City of Albuquerque

Re: Gibson Corridor – 118th St to Amole Arroyo DMP

Engineer's Stamp dated 5-8-03 (N9/D4)

MASTER DRAINAGE STUDY

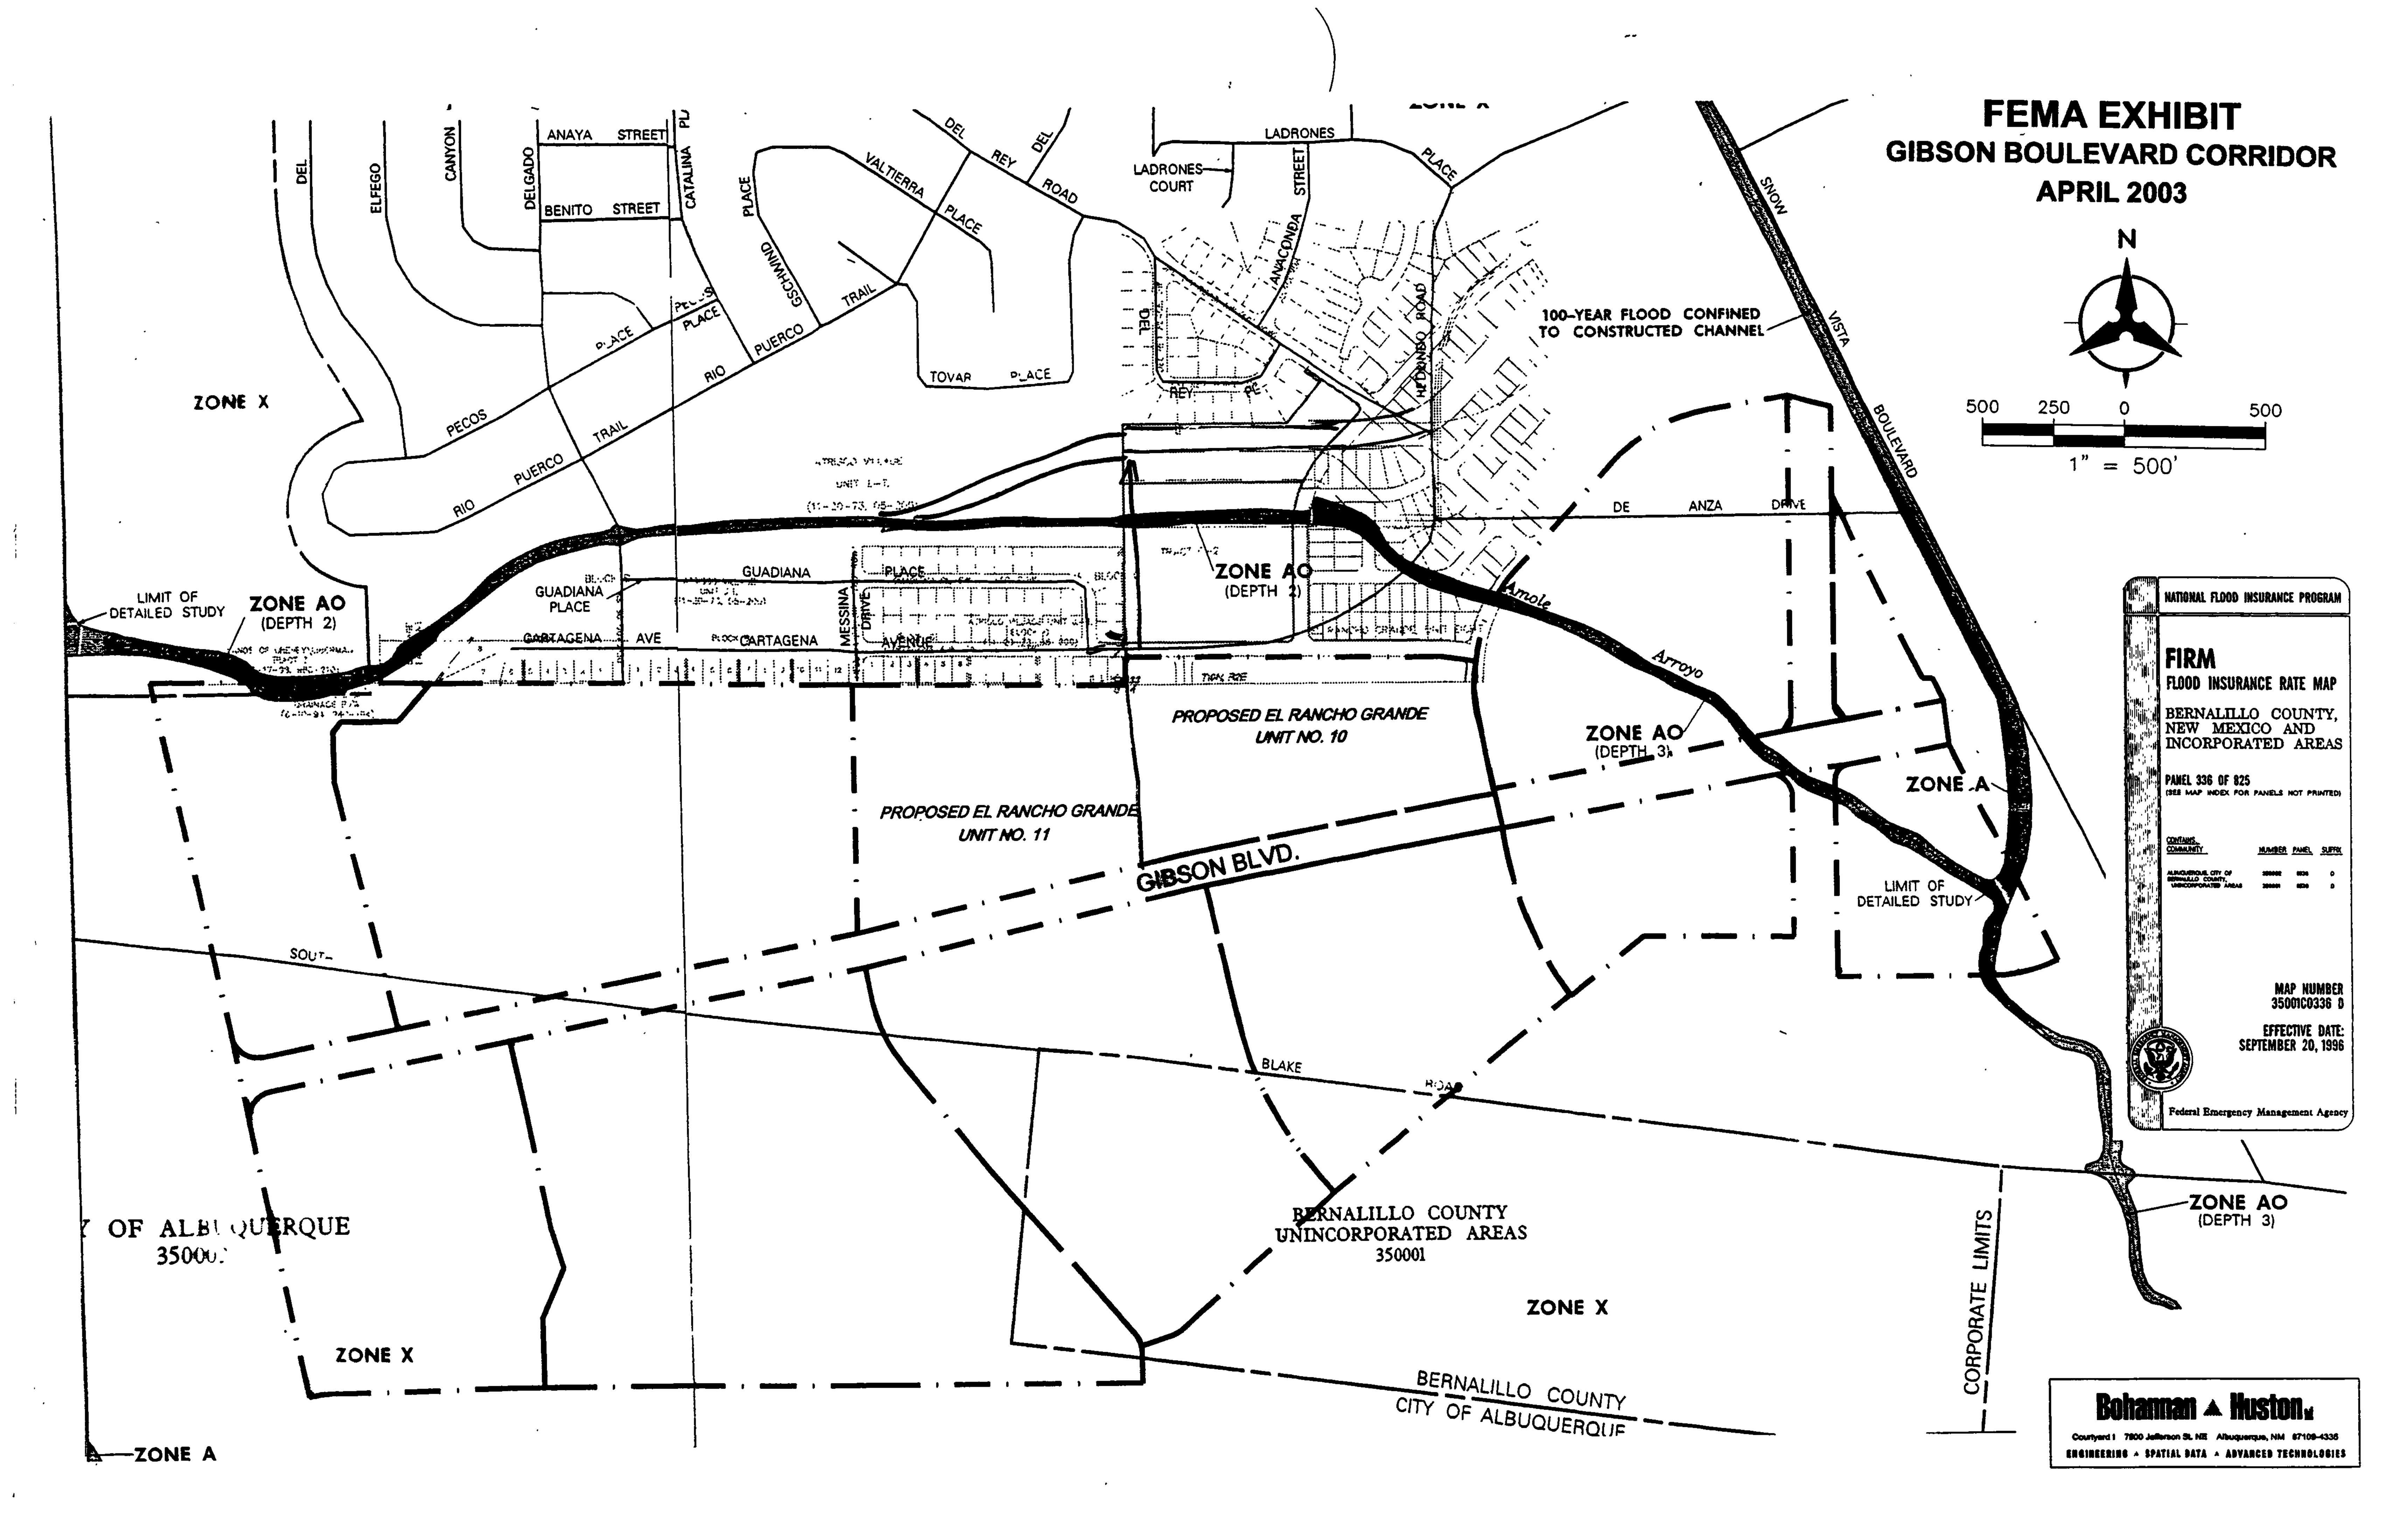
- On the land treatment map, Basins DB9, DB11 and DB12 infer residential development but the Rio Bravo Sector Plan designates these basins as commercial zoning. Please revise the map.

- Basin DB4 (Gibson) should be broken up at AP2 to be consistent with the AHYMO model.
- It would be more prudent to include Basins DB1 and DB2 into the Gibson system. It would better balance the analysis points AP12 and AP9. Plus once the El Rancho units 10 and 11 develop, the eastern portion of DB2 would be more apt to be developed.

- The Amole Arroyo (with applicable analysis points denoted) from the Snow Vista confluence to your southerly entry point should be included your model. What improvements are needed in the Amole in this reach?
